VALUE ENGINEERING STUDY

Project # CSSTP-0006-00(252) PI No. 0006252
Project # CSSTP-0006-00(253) PI No. 0006253

**S.R. 44 from US 441 to I-20
Putnam/Greene County, Georgia**

6 December 2012

PROPOSAL NUMBER: R2-9

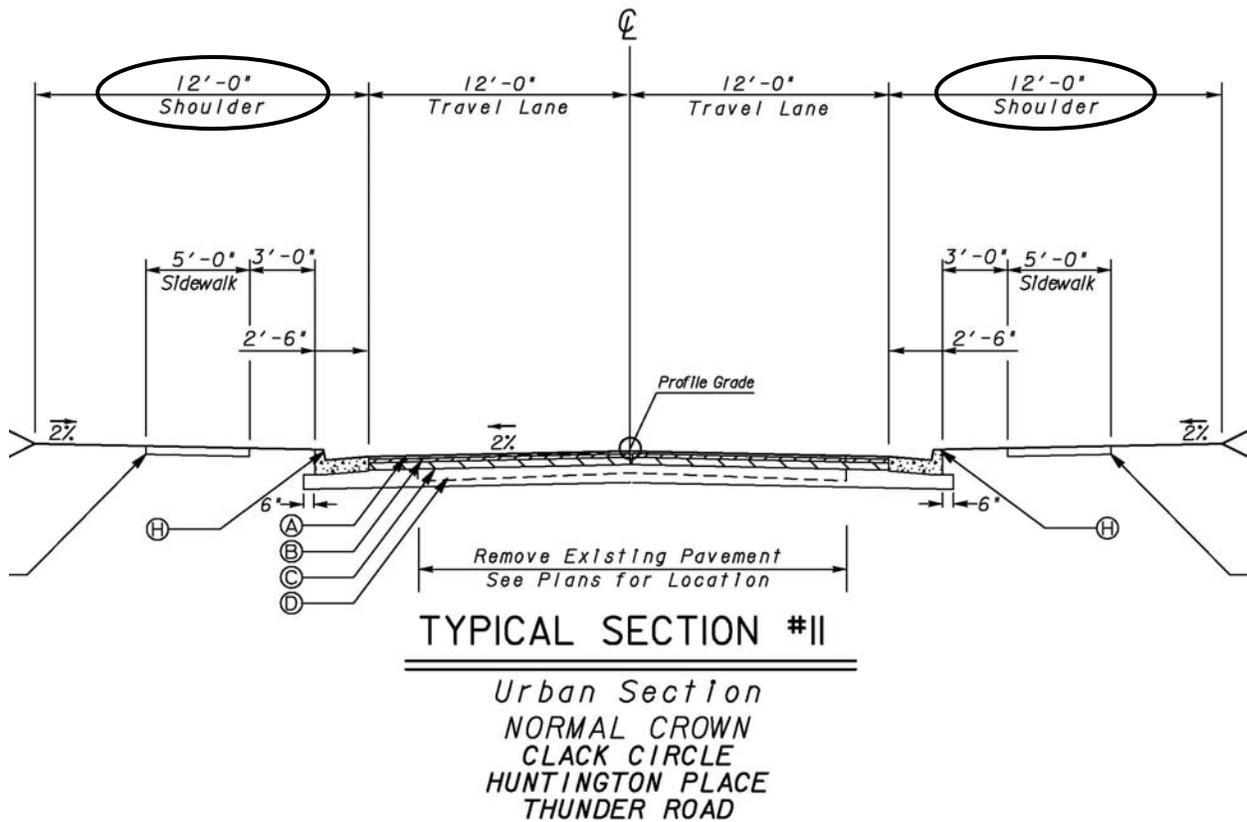
PROPOSED CHANGE: It is proposed to reduce the total shoulder width on the urban side street sections from 12' to 10'.

Proposed Change: Reduce total shoulder width from 12' to 10'

PROPOSAL NUMBER: R2-11

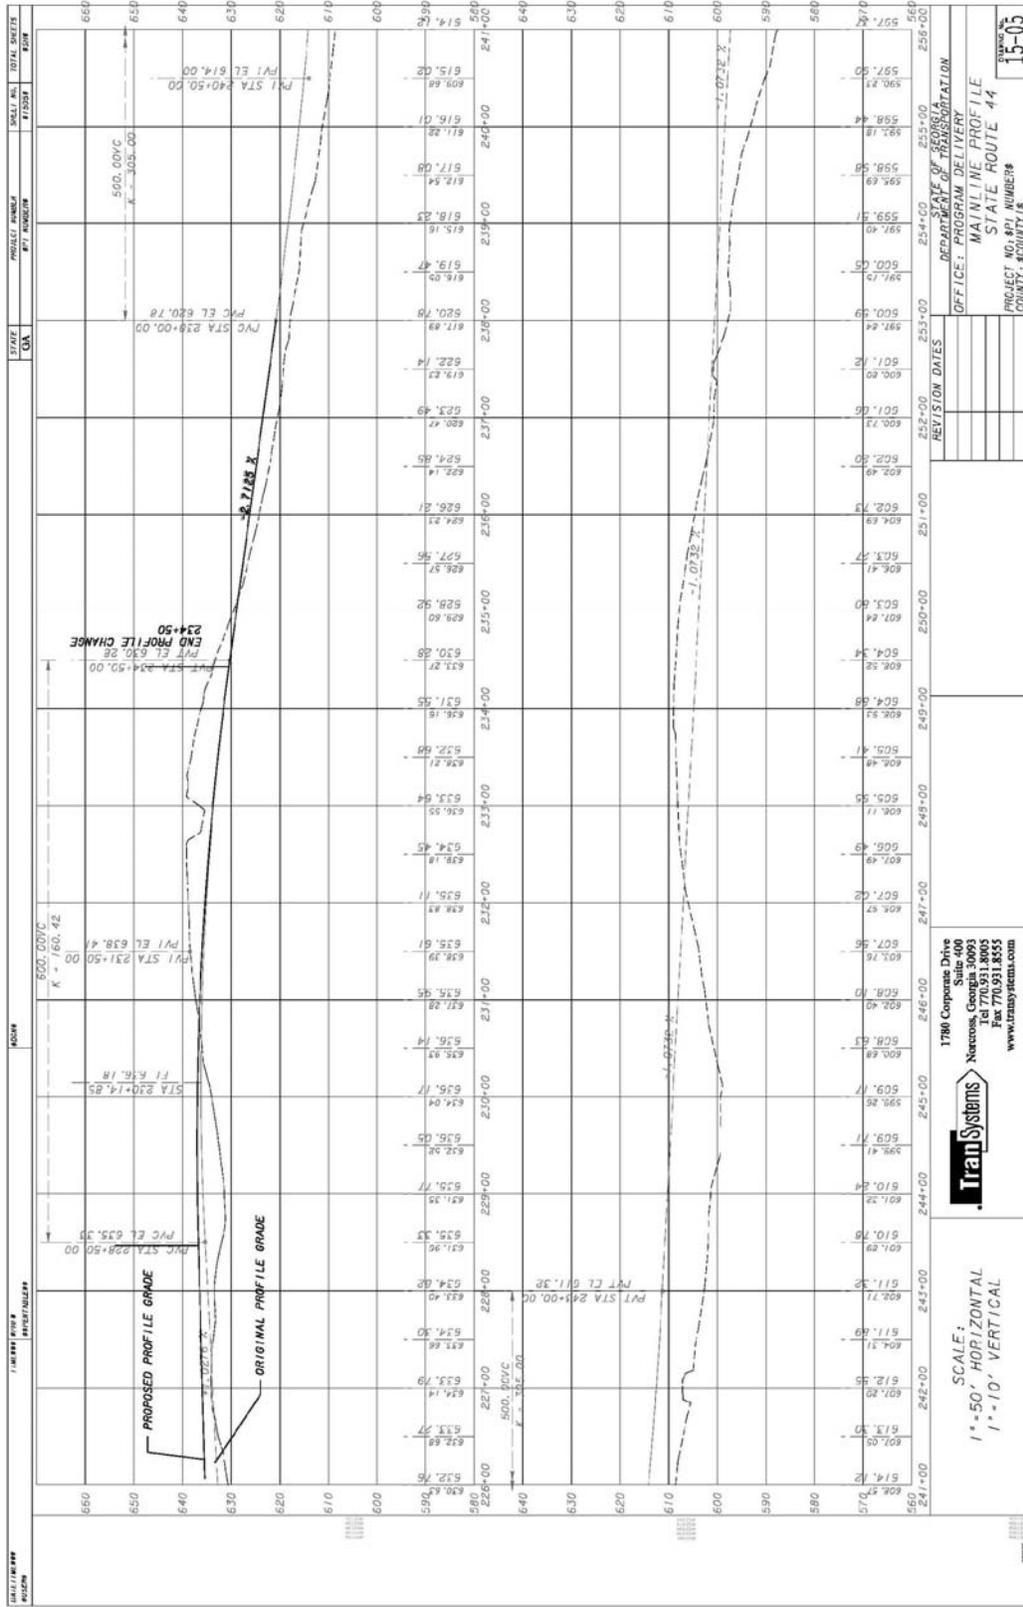
PROPOSED CHANGE: It is proposed to develop a vertical profile from Sta 115+00 to Sta 234+00 that more closely follows the existing terrain or roadway and still meets the desired speed design of 55 mph. The bridge over Rooty Creek will also be lowered to reduce the length and therefore will reduce the cost. (See B2-1 for additional bridge information)

JUSTIFICATION: The vertical alignment can be revised to reduce earthwork and still maintain the required design speed of 55 mph and meet the requirements of GDOT and AASHTO.

R2-12 Original Design
8 of 17

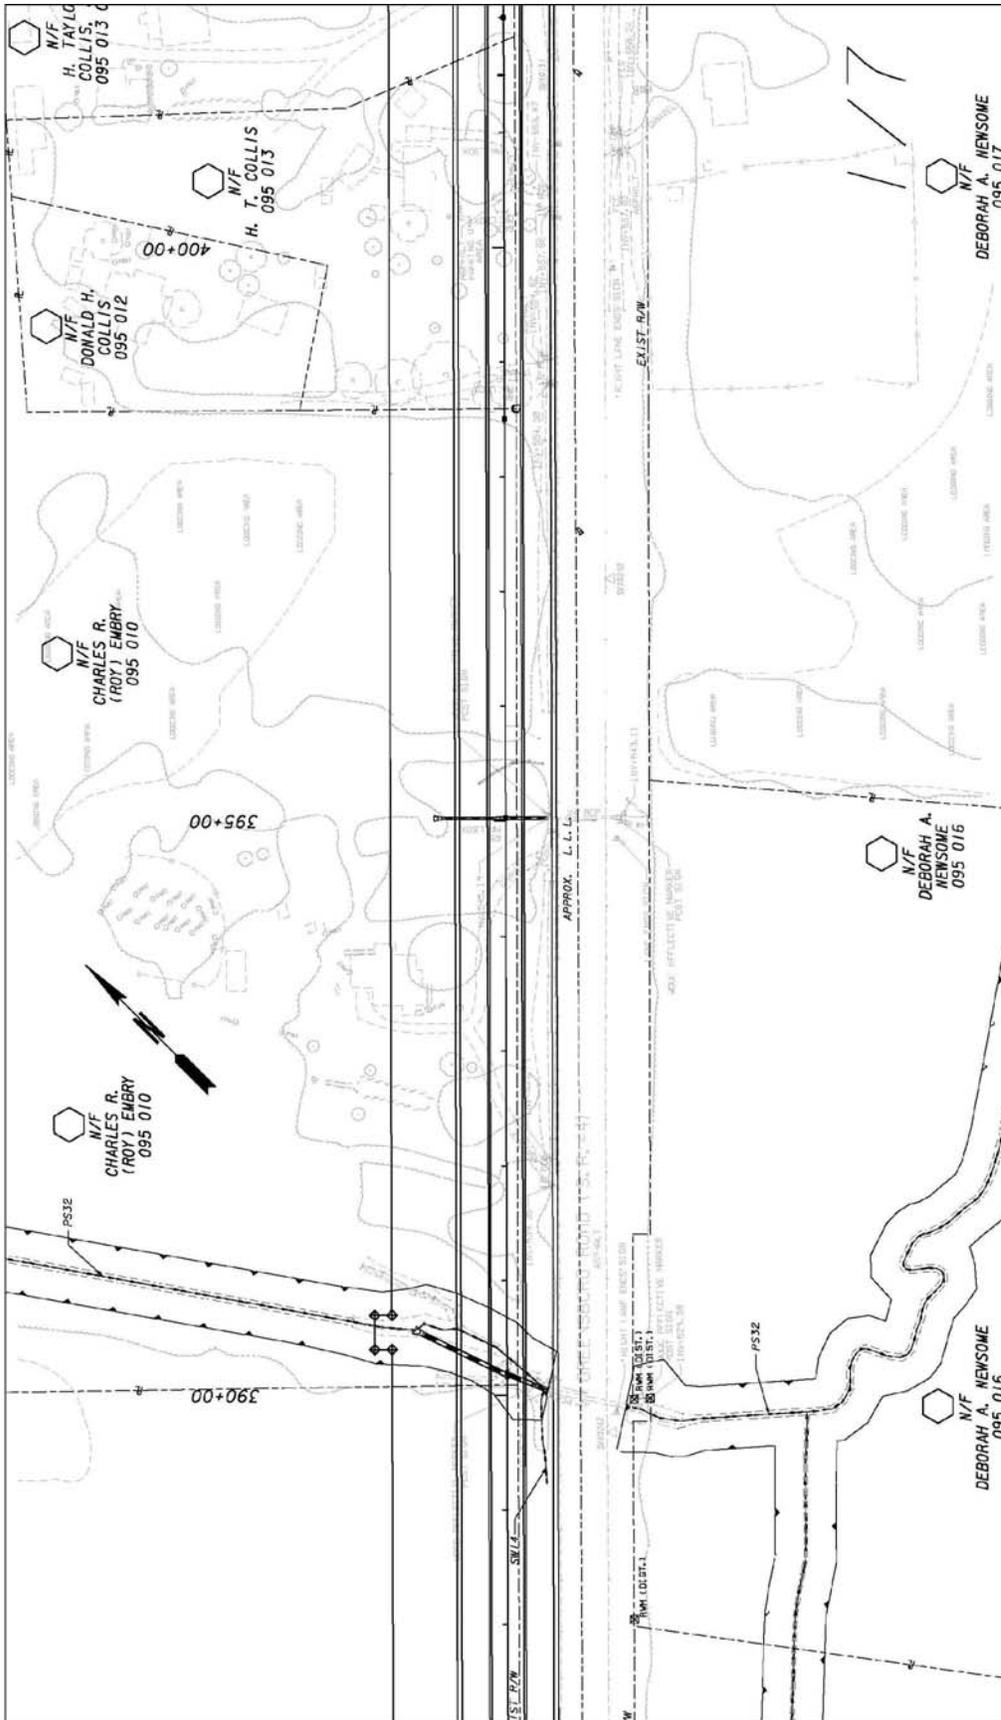
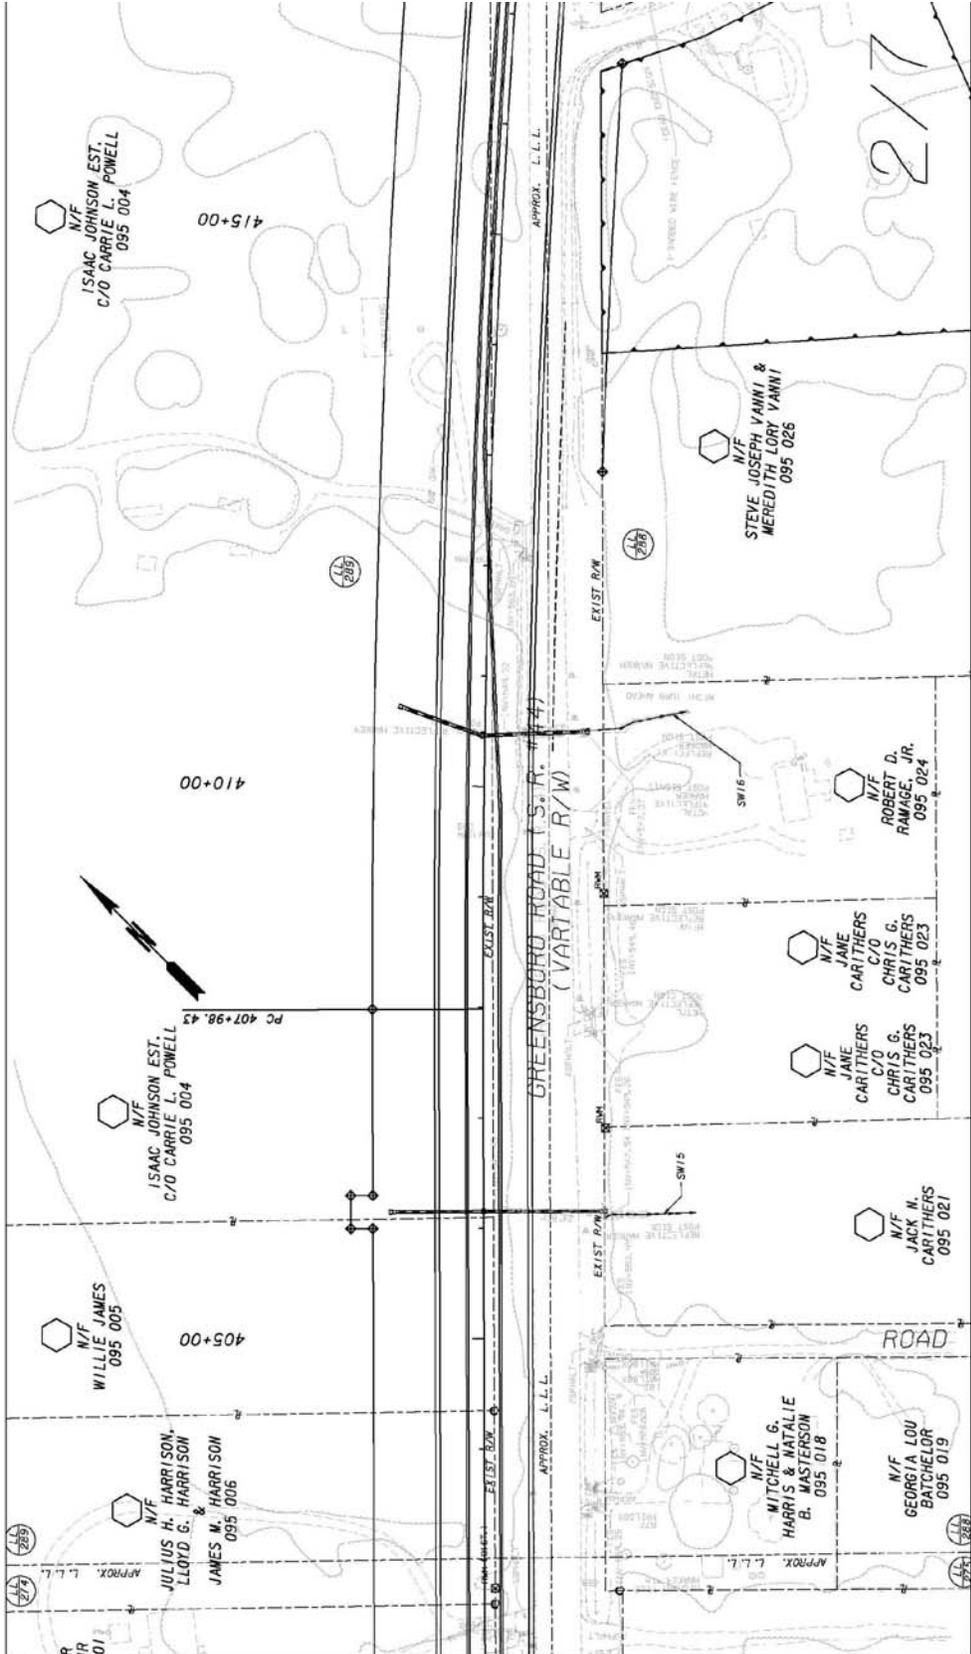
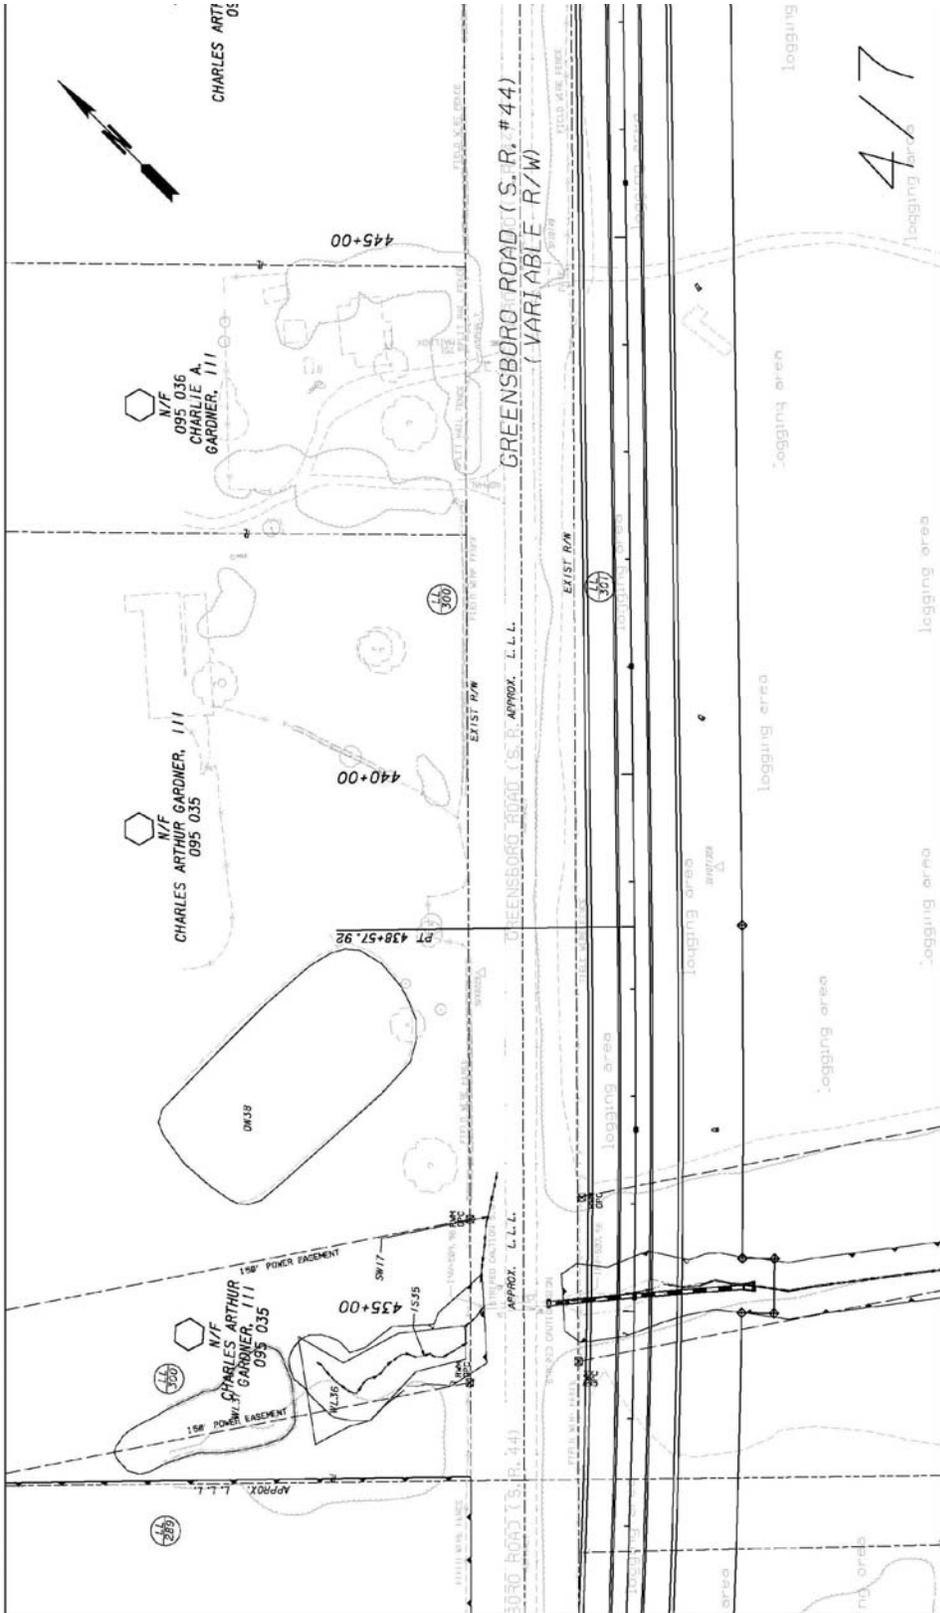
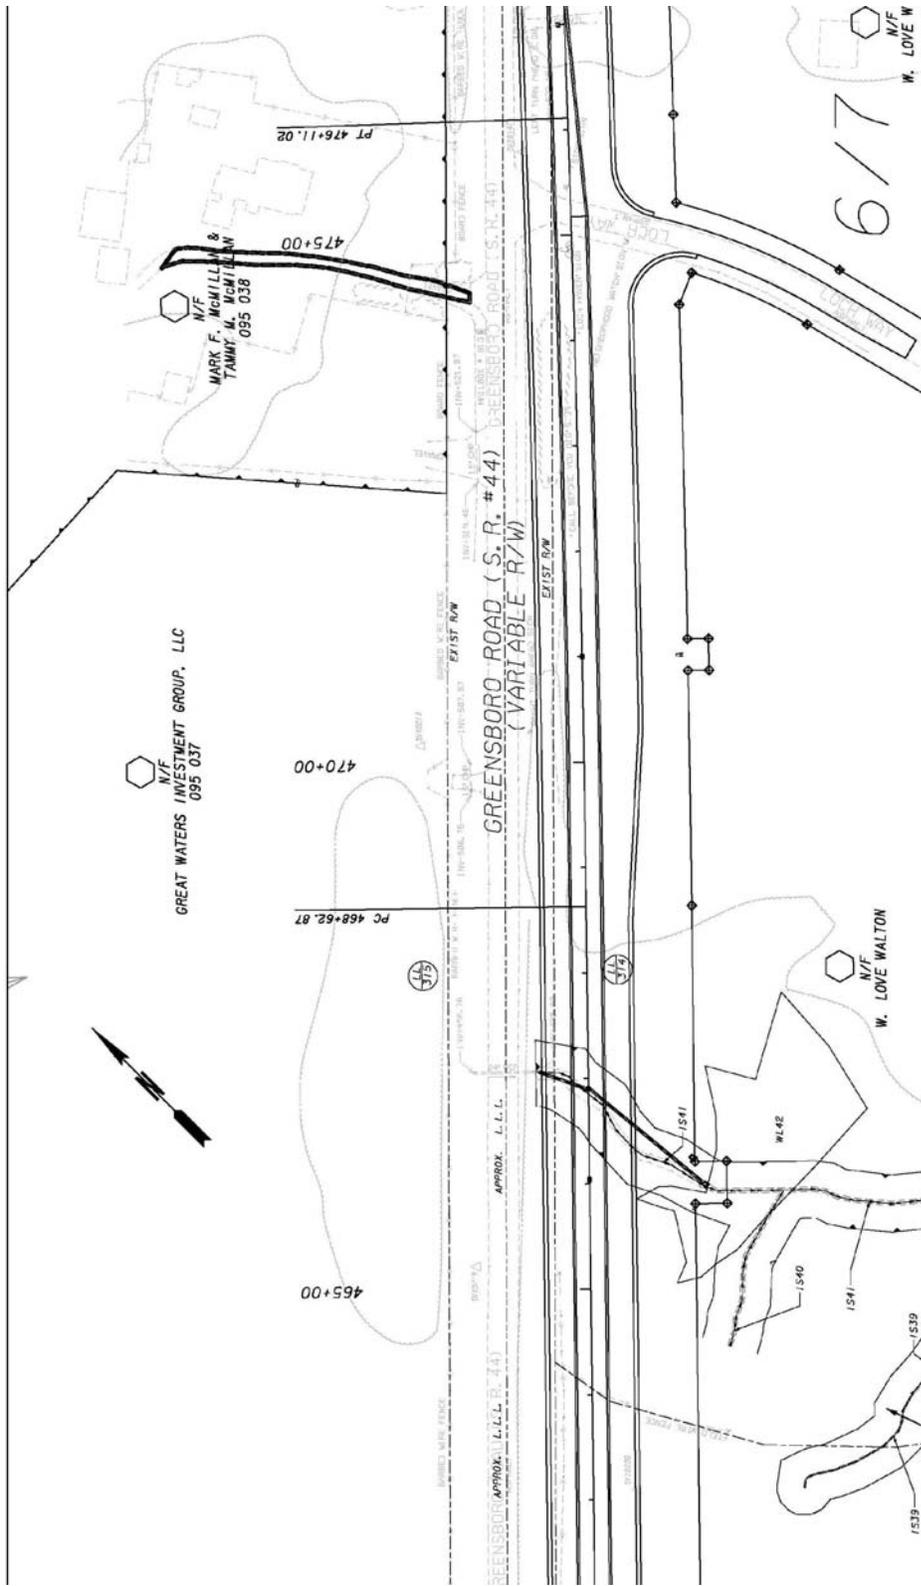
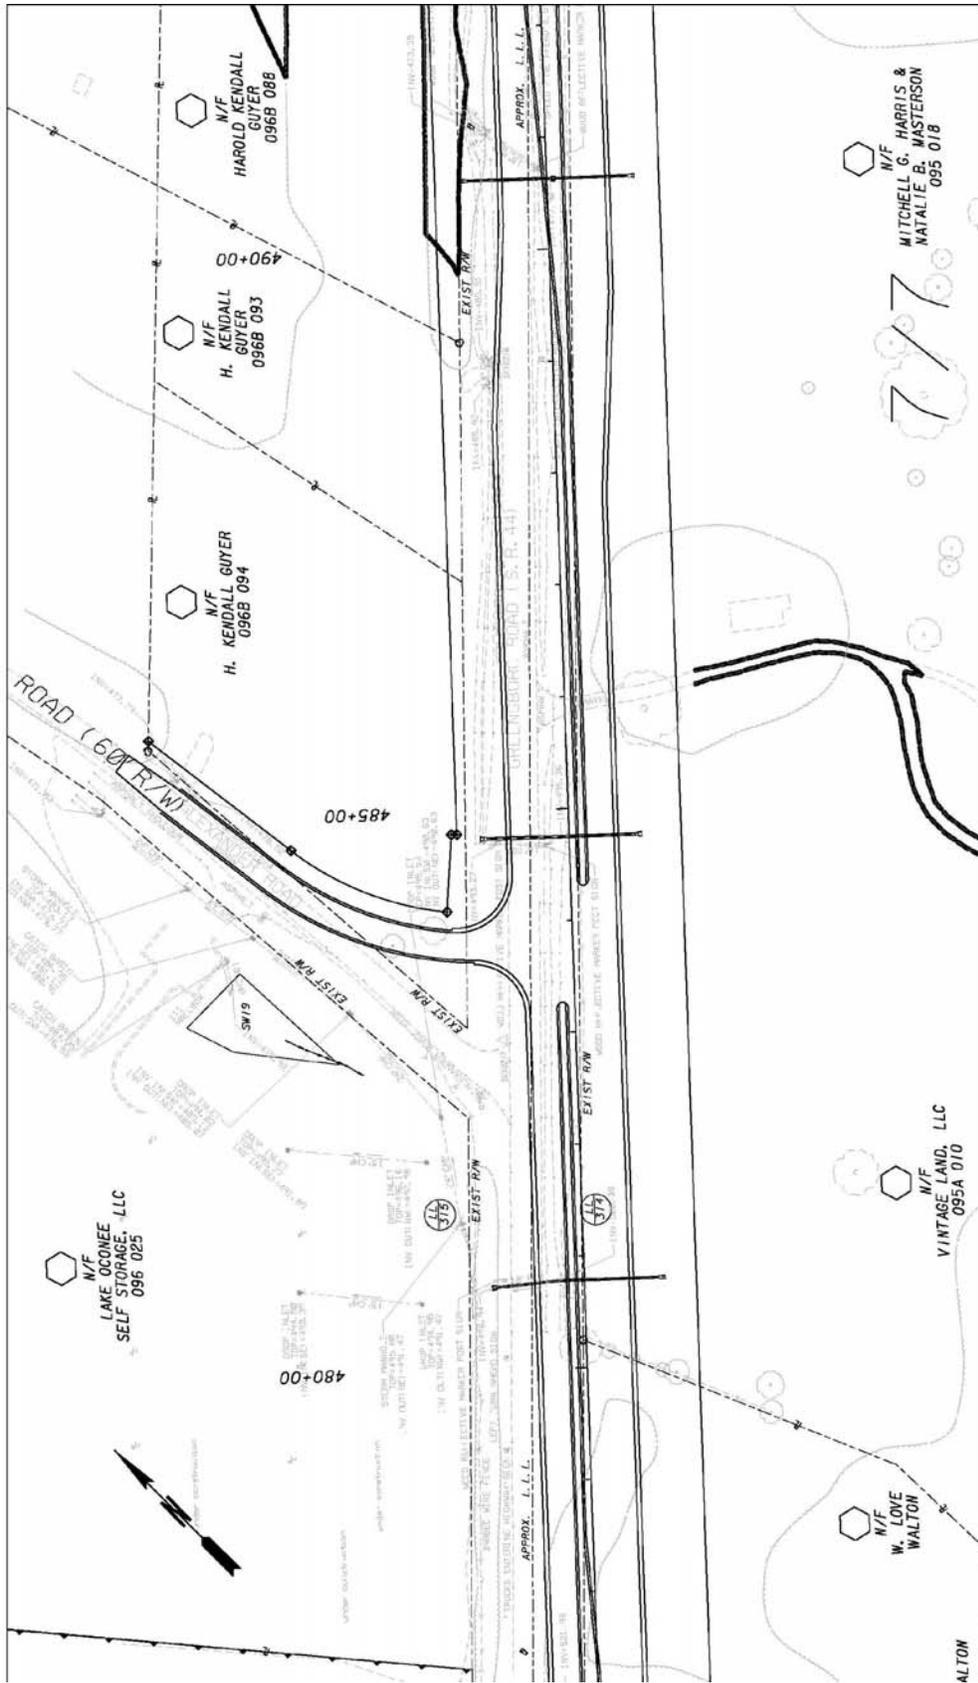
PROPOSED CHANGE: It is proposed to shift the horizontal alignment of SR44 to more closely follow the existing alignment and avoid the displacements on the West side of the road.

JUSTIFICATION: With the removal of the eligibility of the historic resource on the West side of SR 44 at Sta. 414+00 the alignment of SR44 can be revised to closer match the existing and will meet the required 55 mph design speed in the rural section and will meet the requirements of GDOT and AASHTO.
